# Product Change Notice

## TUBULAR SOLENOID

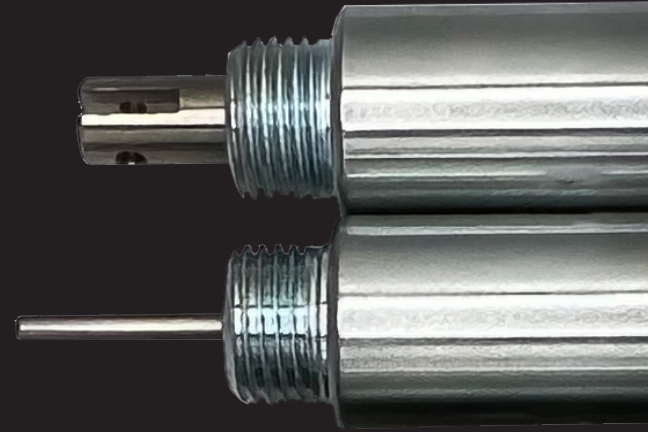
In our continuing efforts to provide a stable supply of cost-effective solenoids, we have undertaken a redesign of our most popular configurations of the STA tubular solenoids. This next-gen tubular design delivers:

An industry standard Molex connector is integrated into the solenoid housing. Customers can now provide their own connections or use the included wire harness.
